NM1 - 5

SUBJECT: Basin Disposal, Inc. [520.01.01/03]
Pond 3 Construction

Re: Basin Disposal, Inc. [OCD Permit No. 1-0005]
Temporary Pond Installation [520.01.01/03]

SUBJECT: Storage Volumes – Evaporation Ponds [520.01.01/01]

Table 1.0
Pond Geometry

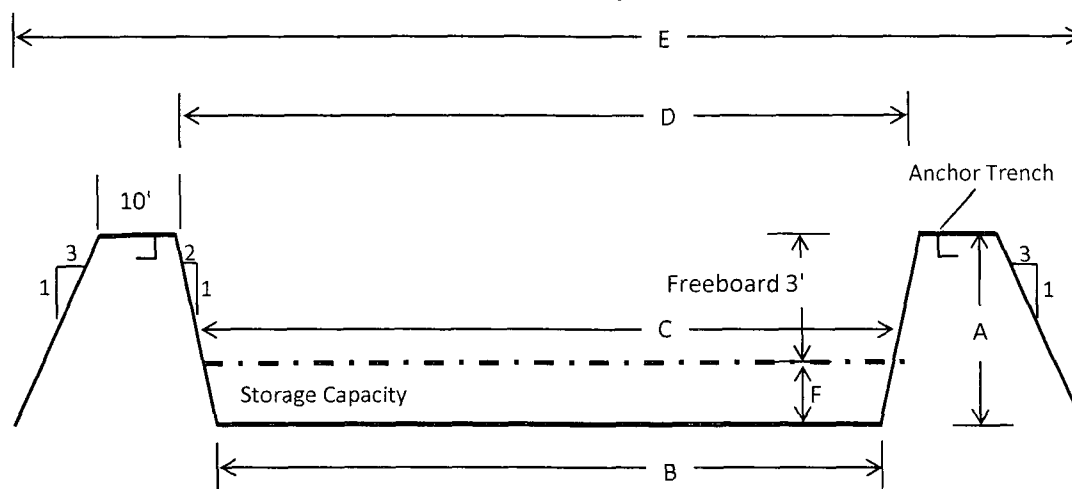
As shown on **Table 1.0**, ponds greater than 2 acres are not feasible when freeboard is subtracted from the capacity calculation (i.e., 10 ac-ft), and a 0.5 acre pond provides over twice the storage capacity as a 2-acre pond (at a fluid depth of 17'). **Table 2.0** demonstrates that maximum pond size is 5 acres when freeboard is not unnecessarily subtracted, and the two-foot minimum depth is maintained. A 4-acre pond optimizes surface area for evaporation, while minimizing the pond footprint.
